RE: Sage Point-Dugout Canyon Mine Plan

FINDING OF NO SIGNIFICANT IMPACT

Applicant: Sunoco Energy Development Company  
Location: Carbon County, Utah  
EPA Action: Issuance of a New Source NPDES water discharge permit  
Application No: UT-0024031

We have reviewed the Addendum to the Mining and Reclamation Plan (MRP) for Eureka Energy Company's Sagepoint-Dugout Canyon mining project. Many of our comments on the original MRP are noted and the response is satisfactory. Some comments are not noted in the Addendum but nearly all of these are of a minor nature or, hopefully, will be answered as the ongoing "Deer-Mining Study" progresses. This study is being conducted in conjunction with this mining project, and we are hopeful that changes will be accepted in the operation if warranted by study results.

Map 3 - Dugout Canyon Cooper's Hawk Nests

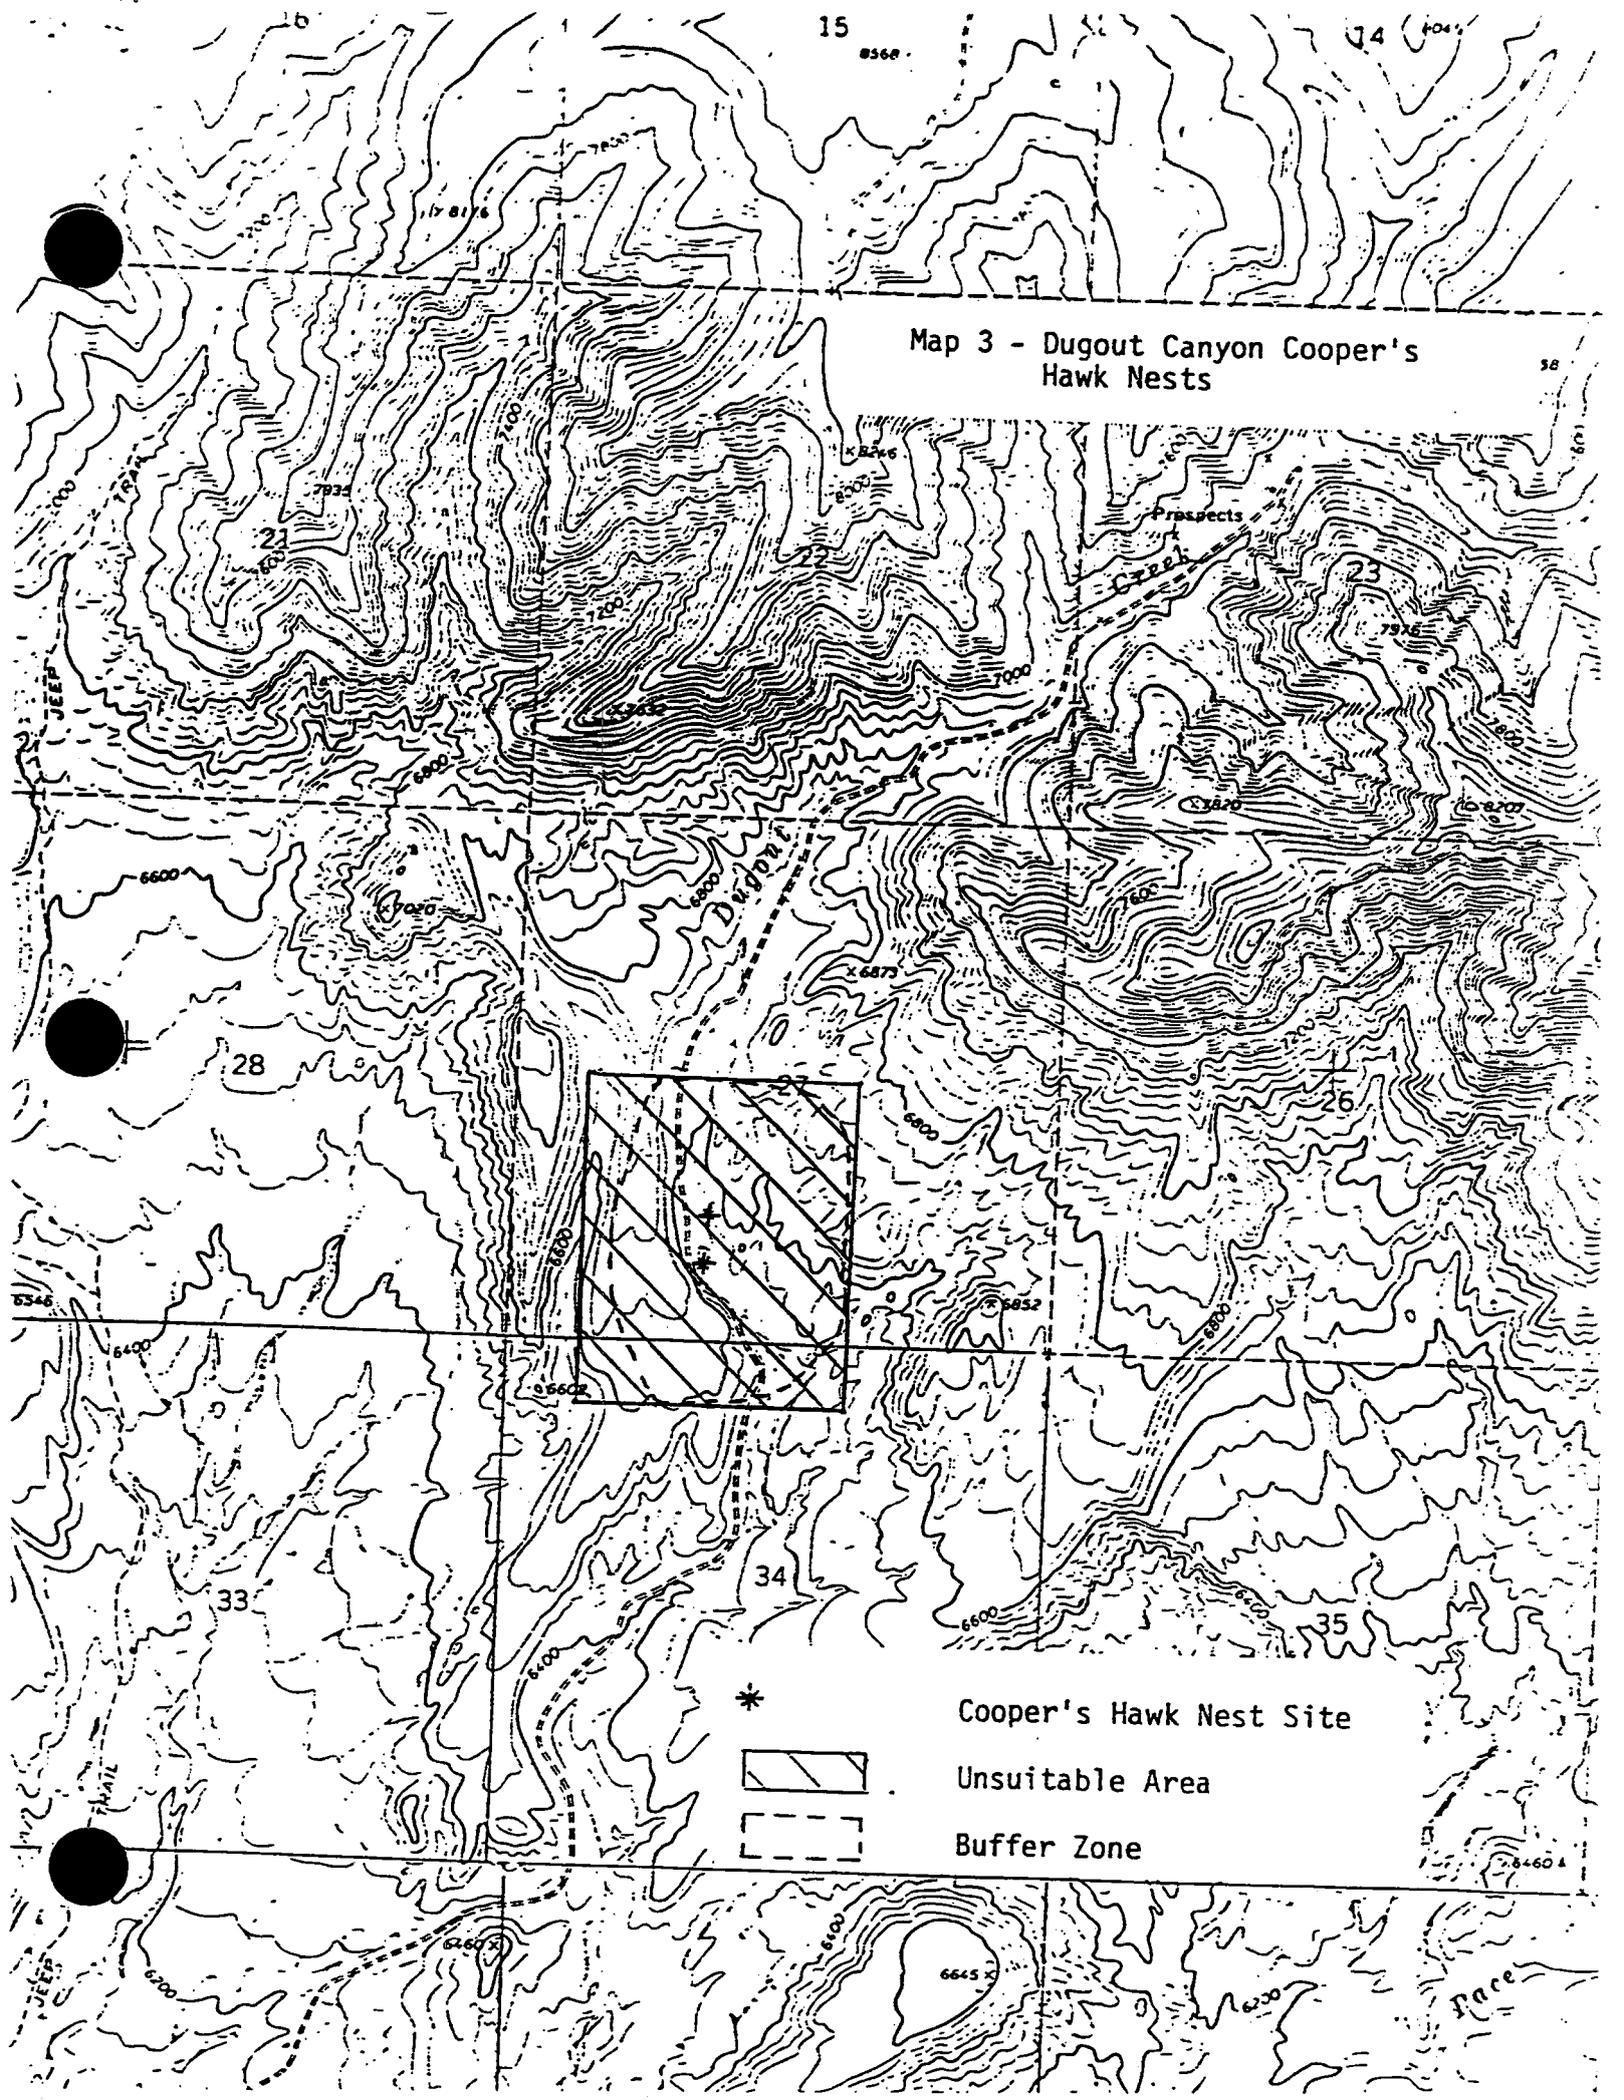
Q. Two Cooper's hawk nests have been documented as active by the BLM and the UDWR. A buffer zone established for the protection of these nest sites is outlined on Figure 4 (attached) and is unsuitable under Criterion 13. An exception can be applied with the following stipulations:

R. One active prairie falcon eyrie, one suspected prairie falcon eyrie and one golden eagle nest site (old) were documented by the FWS and the UDWR. A buffer zone delineated on Figure 4 identifies the area considered unsuitable according to Criteria 11 and 13 of the Unsuitability Criteria. An exception can be applied to allow limited surface disturbance based on the following stipulations:

1. Surface construction activities may be prohibited within the buffer zone (Figure 4) during the critical nesting period, March 15 to June 15. Surface construction may be initiated on June 1 if a nesting attempt has not been documented by the lessor in consultation with the FWS. Surface construction may also be initiated on June 1 if a determination by the lessor, in consultation with the FWS, shows the nesting attempt to be nonproductive. This determination
